EAGLE MOUNTAIN CITY

City Council Staff Report

NOVEMBER 18, 2014

Project:	**Gateway Park**
Applicant:	Scot Hazard
Request:	*(1)* Rezone areas of the property to Business Park and Commercial Storage
	(2) Master Site Plan
	(3) Preliminary Plat
Type of Action:	Public Hearing; Action Items
Planning Commission:	Recommended Approval (5-0) w/ conditions

SHEET NAME	SHEET NUMBER
UTILITY (NORTH)	C2A

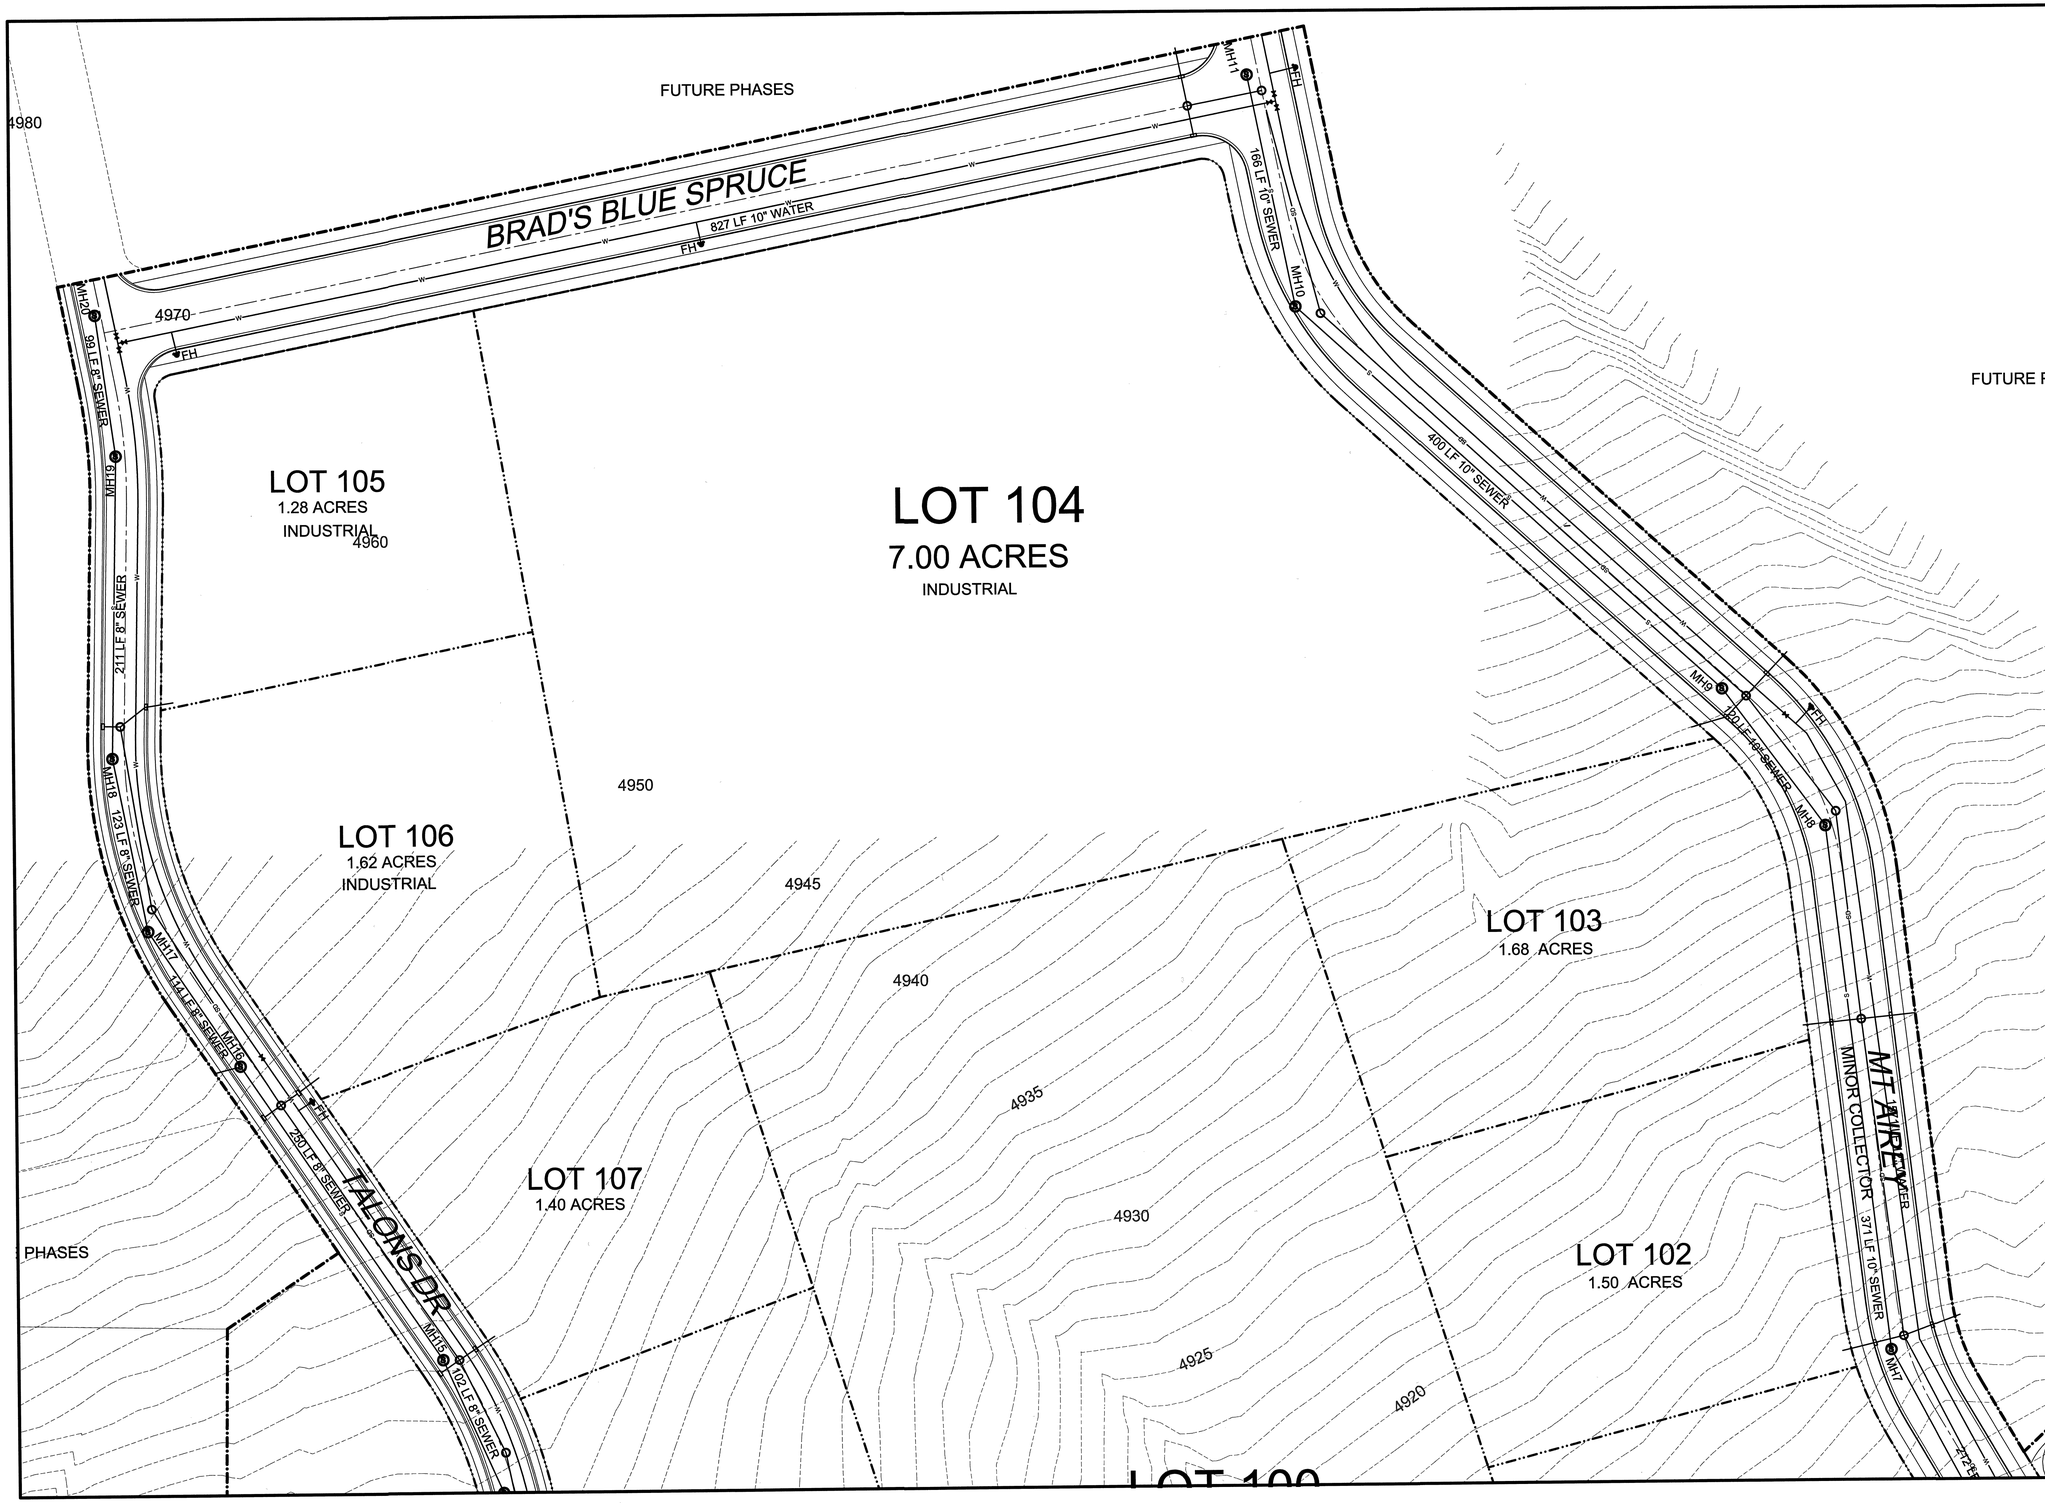
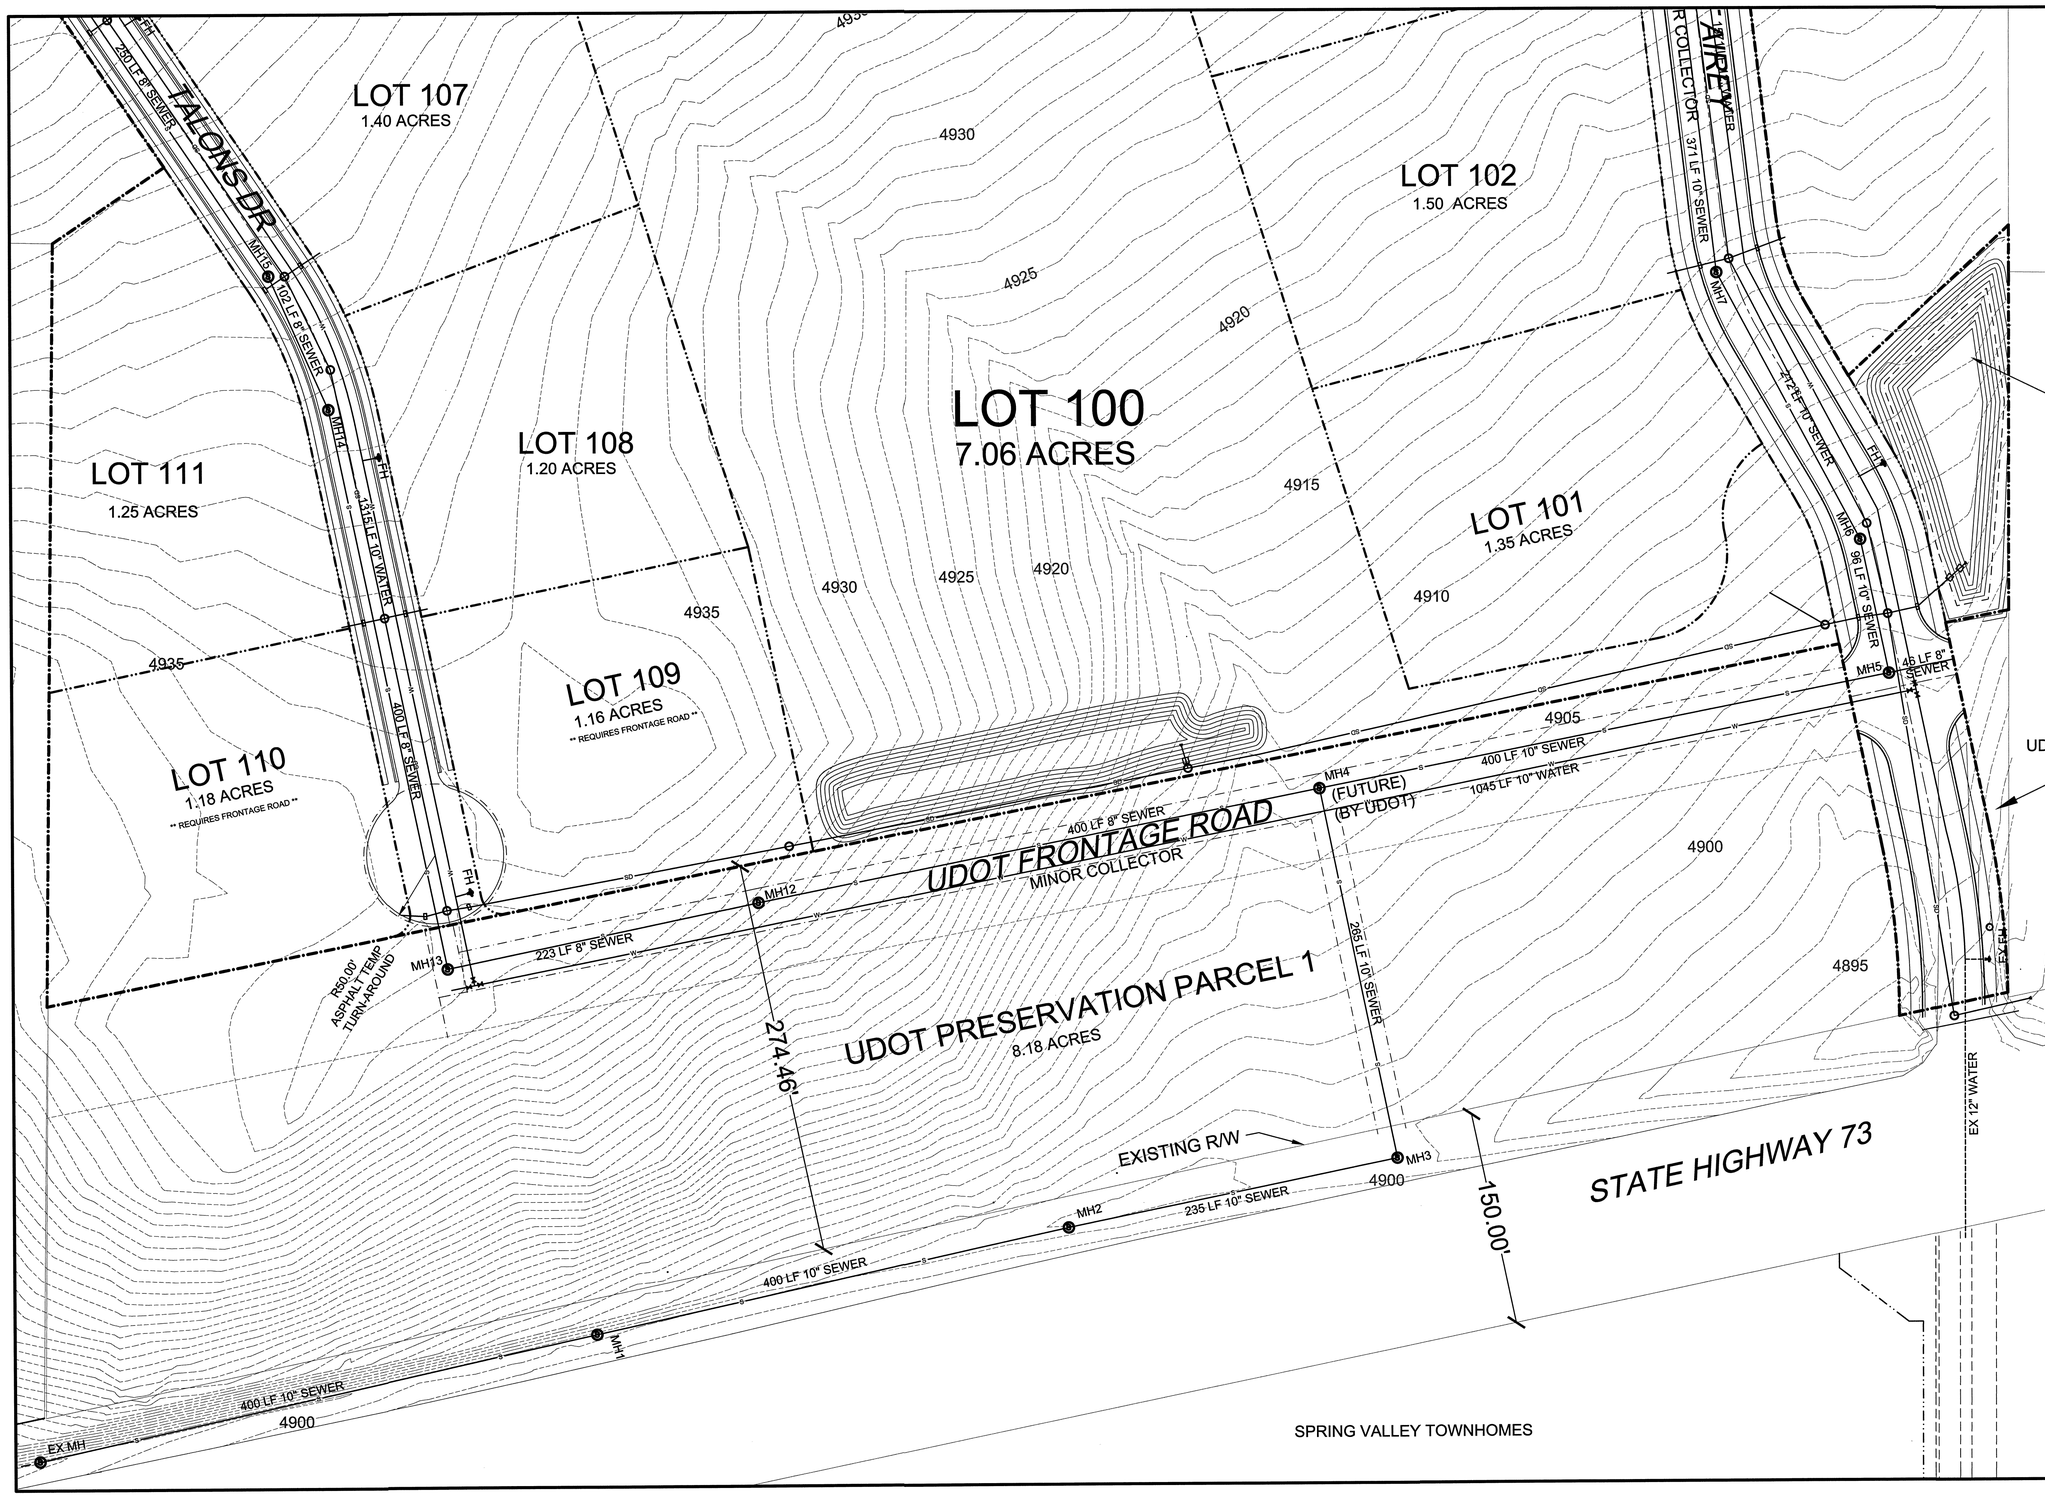
The utilities have been reviewed by the City Engineer. Water modeling is required for this project. The project must comply with any determinations from the water model, whether it means upsizing water lines, building a water tank, or some other solution. Utility plans will have to be finalized with final plat applications.

1. *Developer must provide a water model for the project and must comply with any requirements as a result of the water model.*
2. *A second access is required for construction or permits for lots 105-111, unless approved by the Fire Marshal.*
3. *Storm drain calculations and plan must be approved by the City Engineer.*
4. *Developer must provide an access agreement with UDOT for utilities located within UDOT right-of-way or install utilities outside of the UDOT right-of-way.*
5. *All offsite sewer will need to be installed prior to construction of phase 1. Provide offsite sewer design with the first final plat.*
6. *A detailed sign plan is required with the first site plan, including details for an entryway monument for the project. The entryway monument must be completed with the first final plat.*
